I. REQUEST FOR ALLOWABLE AND AUTHORIZATION TO TRANSPORT

<sup>1</sup> Operator name and Address Hilcorp Energy Company 382 Road 3100 Aztec, NM 87410		<sup>2</sup> OGRID Number 372171	
		<sup>3</sup> Reason for Filing Code/ Effective Date RC	
<sup>4</sup> API Number 30-045-26417	<sup>5</sup> Pool Name Basin Fruitland Coal		<sup>6</sup> Pool Code 71629
<sup>7</sup> Property Code 318560	<sup>8</sup> Property Name Houck		<sup>9</sup> Well Number 2E

Houck 2E  
30-045-26417  
NMSF077092  
SR Recomplete

## Current Schematic - Version 1

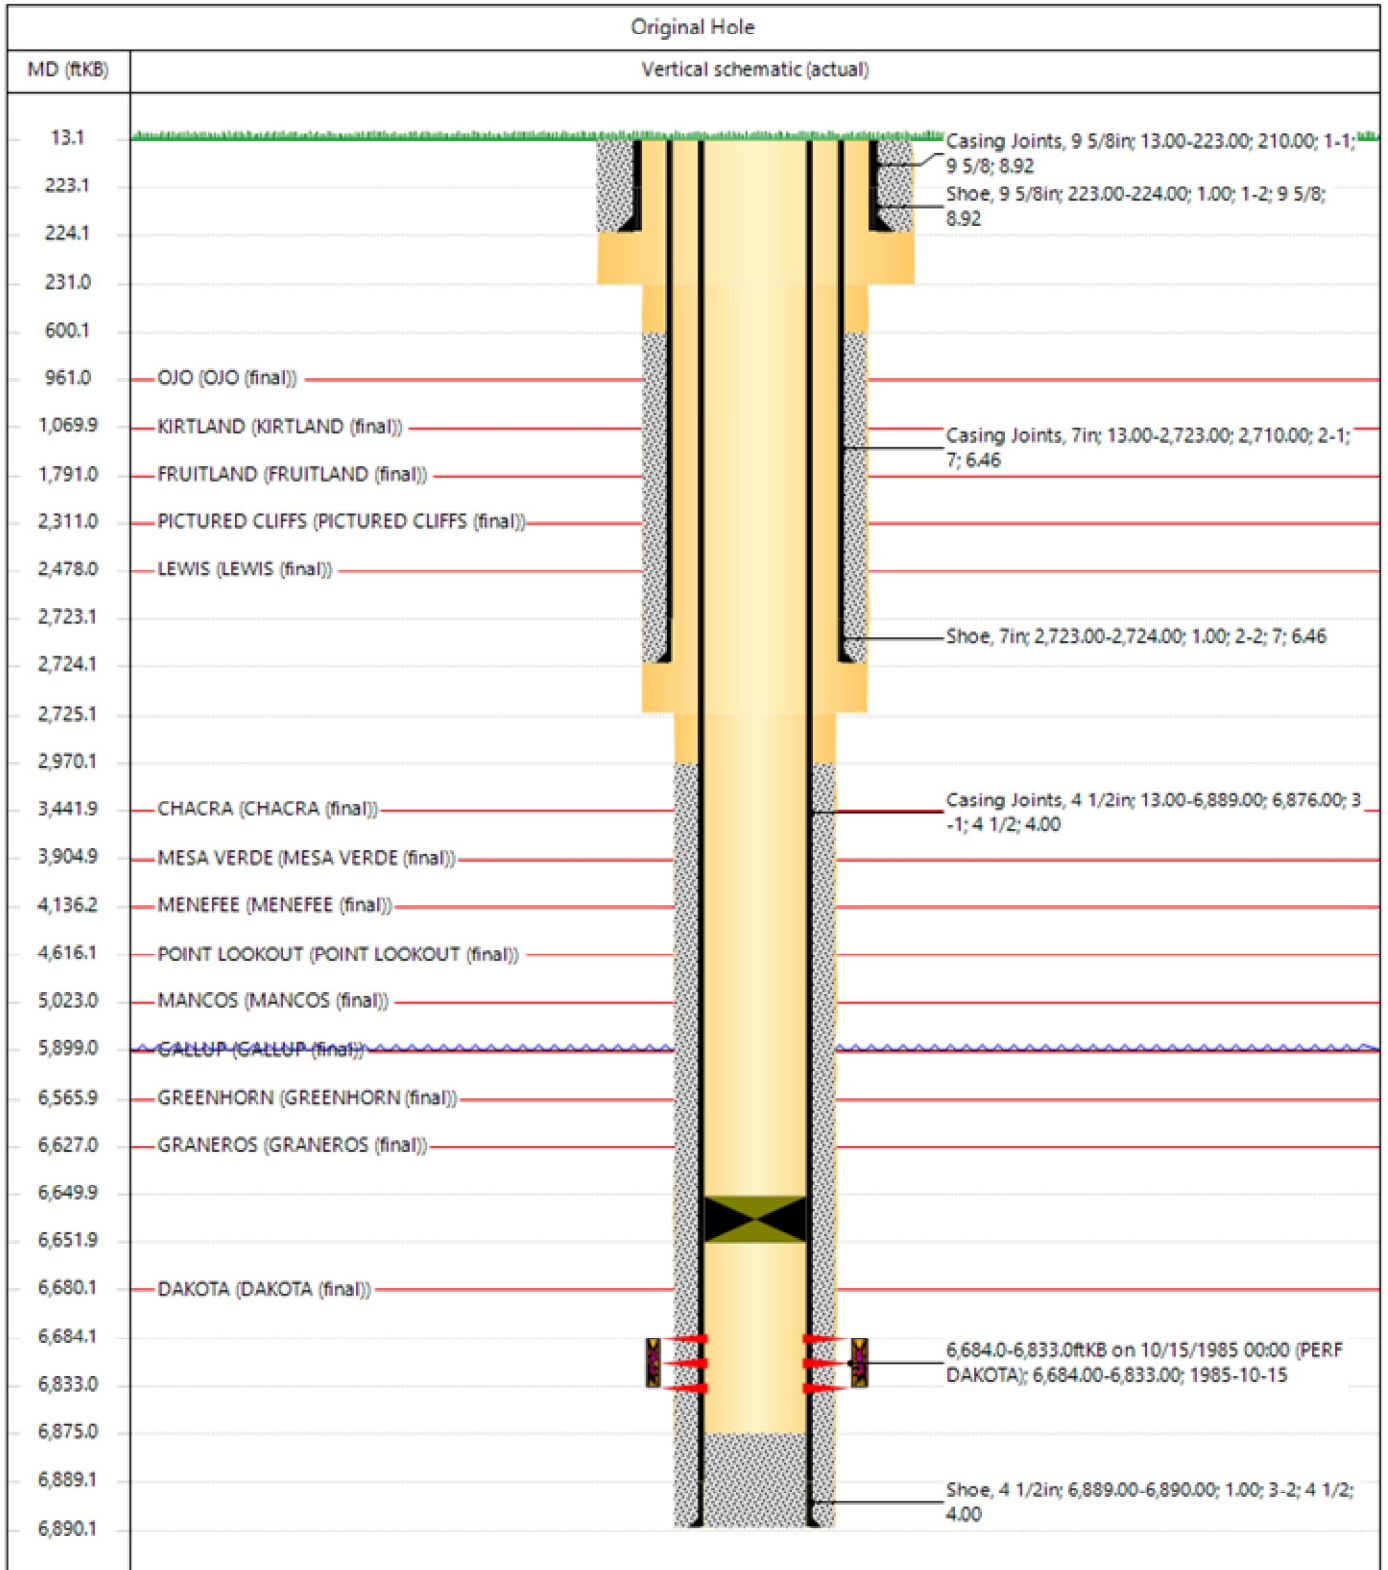
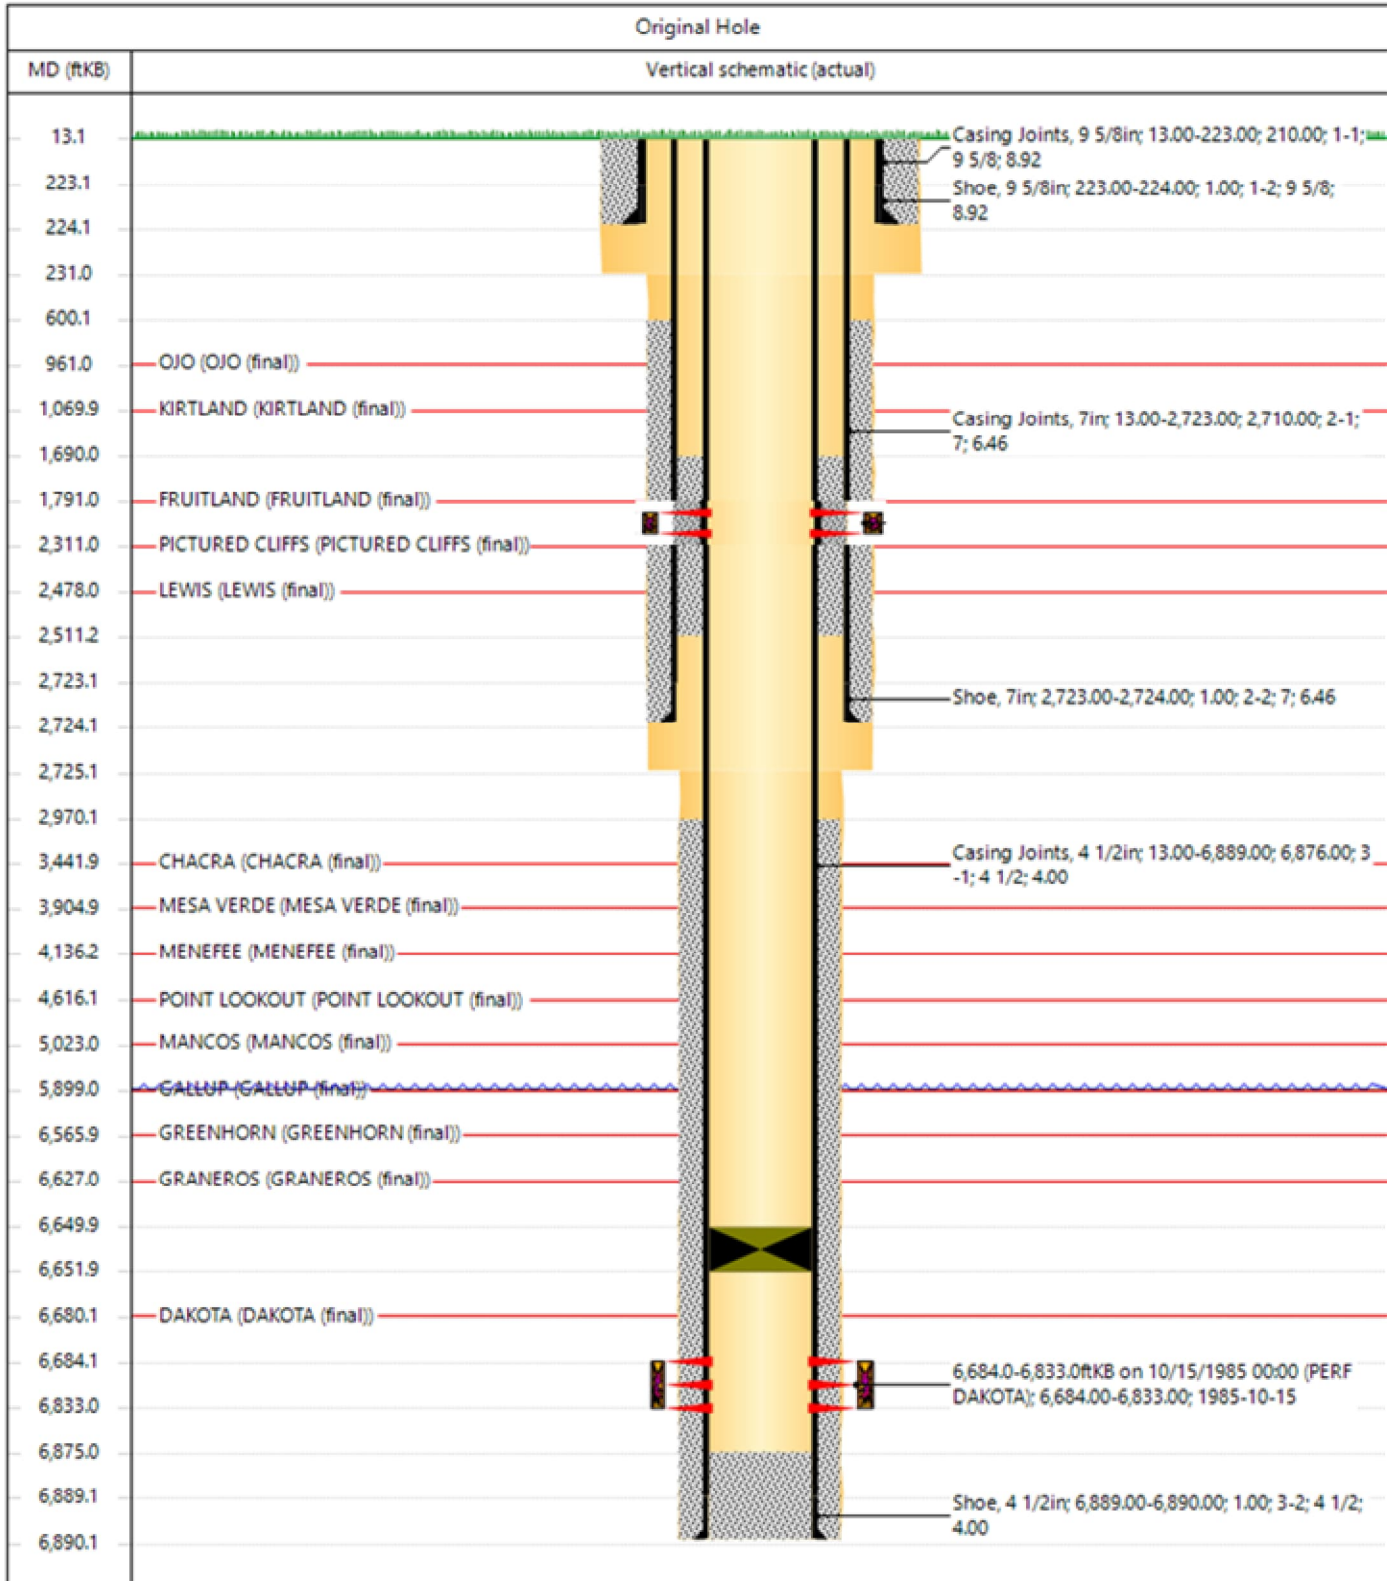
NMOCD approval is given to cement from 2500 feet – cbl required after cementing and drill out. – Please keep track of pressures on bradenhead and intermediate through workover – schematic shows no cement in bradenhead or across intermediate shoe.

Please see the attached CBL that was ran during the recompleat wellbore prep for Houck 2E. Based on the CBL – we do not have adequate cement coverage across our zone of interest (NOI approved interval: 1791' – 2311'). Current TOC 2,970'.

We would like request approval to shoot squeeze holes at +/- 2500', set a cement retainer and circulate cement up the 4-1/2" x 7" casing annulus to achieve sufficient cement coverage across the Fruitland Coal interval. Current and proposed well schematics are below for reference. Please let us know if we may proceed.

The BLM finds the cement remediation proposal appropriate.
